INFORMATION LETTER 010

TITLE: Rotax 912ULS airbox seal

Figure 1: Filter edge seal and airbox clips

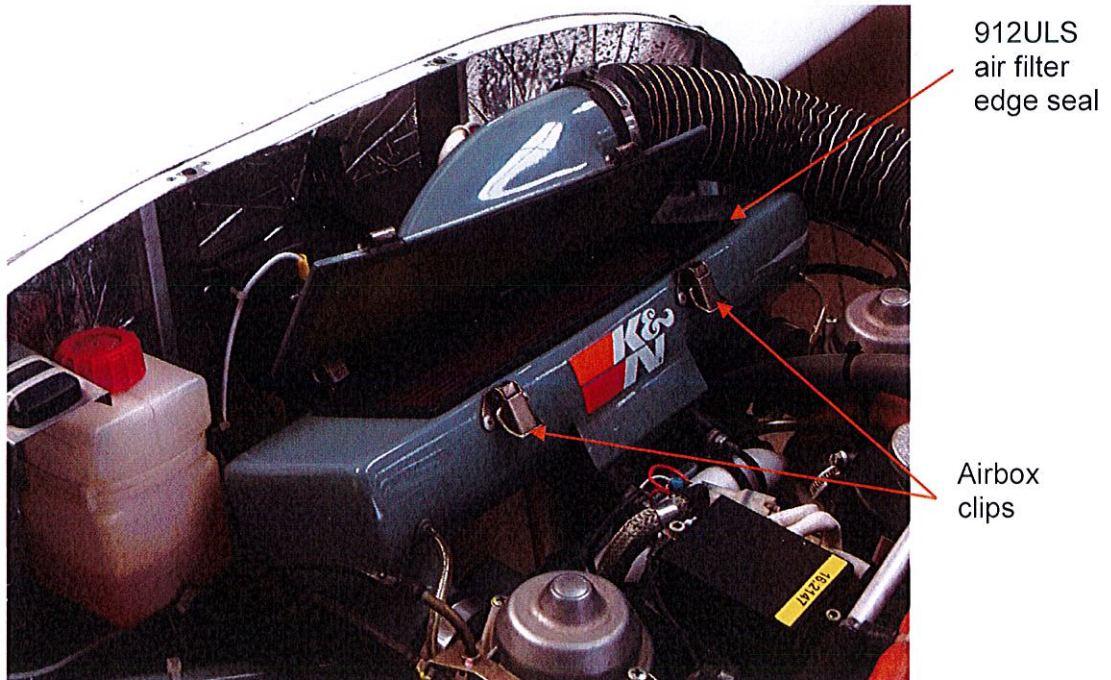
REASON: During initial fitment of the 912ULS air filter, the edge seal (see Figure 1) of the air filter creates a tight seal to prevent ingress of water and other foreign particles into the airbox through its lid. However, the airbox lid may develop some play due to flattening of the air filter edge seal with time.
